STATE OF DELAWARE
EXECUTIVE DEPARTMENT
OFFICE OF MANAGEMENT AND BUDGET
STATE PLANNING COORDINATION

RE: PLUS review – PLUS 2005-11-10; Reed Plantation Acres

Thank you for meeting with State agency planners on November 30, 2005 to discuss the proposed plans for the Reed Plantation Acres project to be located on US. Route 1, near Frederica.

According to the information received, you are seeking site plan approval for 254 residential units and 90,000 square feet of commercial floor space on 106.44 acres.

Reed Plantation Acres (PLUS 2005-11-10) with excellent recharge in green and affected parcels outlined in light blue.

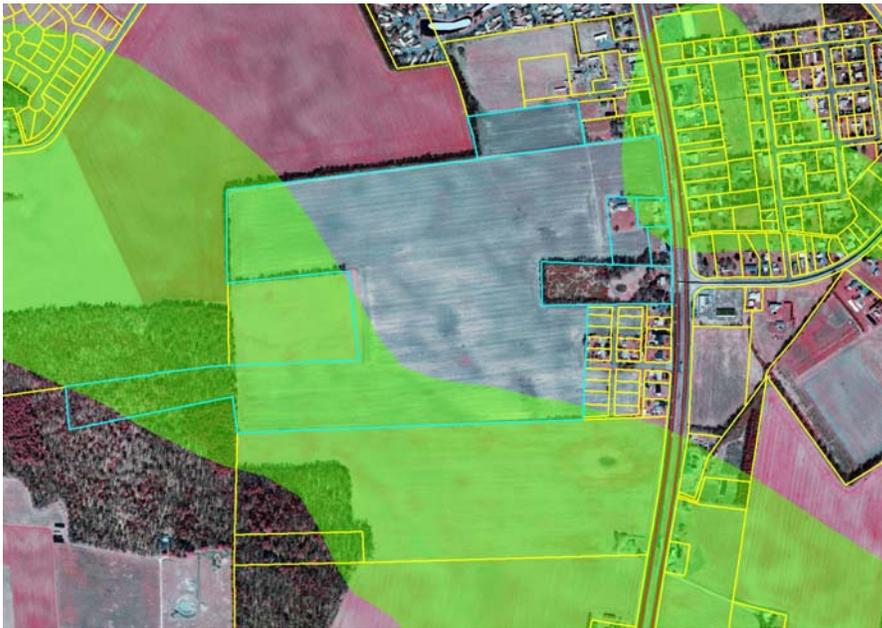
The DNREC Water Supply Section has determined that the southern edge, southwestern section and a section in the northeast of the proposed development falls within an area of excellent groundwater recharge (see following map and attached map).

The proposed development would change the total impervious cover from .08% to approximately 36% in proposed development area. The proposed development area impacts the excellent recharge area. The numbers were provided by the developer on the PLUS application.

The southern edge, southwestern section and a section in the northeast of the development area is proposed to be single family home lots and some open space. If possible, the amount of open space in this area should be increased to decrease the amount of excellent recharge area that is impacted by development. Currently the larger

open space areas are located away from the excellent recharge areas. This should be changed.

DNREC Water Supply Section recommends that that portion of the new development within the excellent recharge area not exceed 20% impervious cover. Further, some allowance for augmenting ground-water recharge should be considered if the impervious cover exceeds 20% but is less than 50% of that portion of the parcel within this area.
